30 August 2021

Ref: 0877

**Private Plan Change 28
Maitahi Bayview – Further Information (Transport)**

Figure 1: Traffic Count Data – July 2021

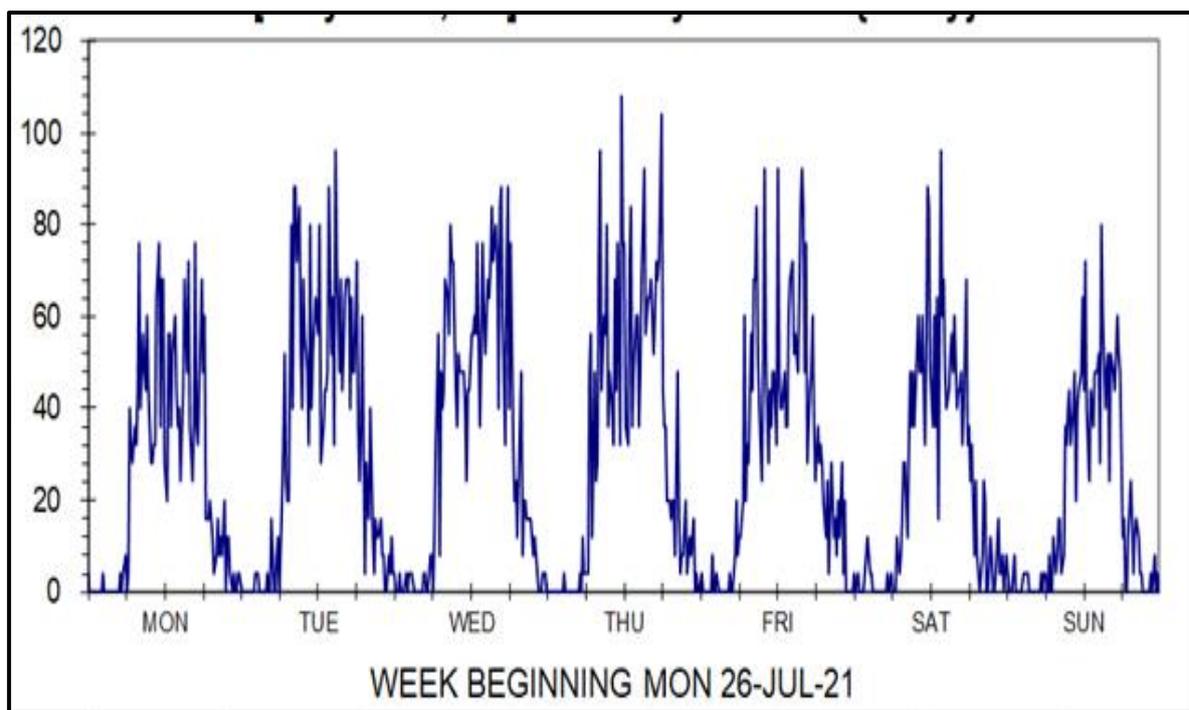
In respect of anticipated traffic generation, please provide:

- a Sensitivity testing of the effects of higher generation and*
- b Mapping of the residential catchments and analysis of the data to validate the appropriateness of the assumptions made.*

Figure 1 below shows the weekly traffic patterns along Bay View Road for July 2021.

As shown the weekly flows are fairly consistent with more traffic using Bay View Road during the week. Traffic counts of the construction traffic associated with the Bay View Development were also carried out for the same time period as the tube counts. There was on average 100 vehicles trips per day during this time over the weekday. The vehicle movements of construction vehicles were recorded with a geofence around the construction site which enable count data to be collated. This accounted for around 5% of the total daily flow on Bay View Road. These flows have been taken off the analysis below.

Therefore, the more recent survey data shows around 725 vehicles per day for a five-day week (670 for AADT) with peak flows of around 65 vehicles in the AM peak and the PM peak. These overall flows are higher than those recorded in July 2019 because the counter was located closer to Atawhai Drive and therefore more homes being included in the traffic count.

The traffic patterns shown in the graph above were similar to the July 2019 survey data with more concentrated flows in the AM peak with PM (evening) flows more spread out. The two traffic counts showed good alignment in regard to the traffic patterns.

The traffic count data showed that the number of trips per dwelling per day was around 6.3. This is lower than the 6.6 trips per dwelling per day measured in July 2019. This is likely to be due to the July 2019 data including construction traffic which has been removed from the July 2021 counts. The location of the traffic counter was closer to the bottom of Bay View Road, which may also affect the trip rates.

The peak hour flows from the July 2021 traffic counts show an AM peak of 0.61 trips per household and an PM peak of around 0.50 trips per household. This would equate to around 458 trips in the AM peak and 375 trips in the PM peak for the Plan Change Area.
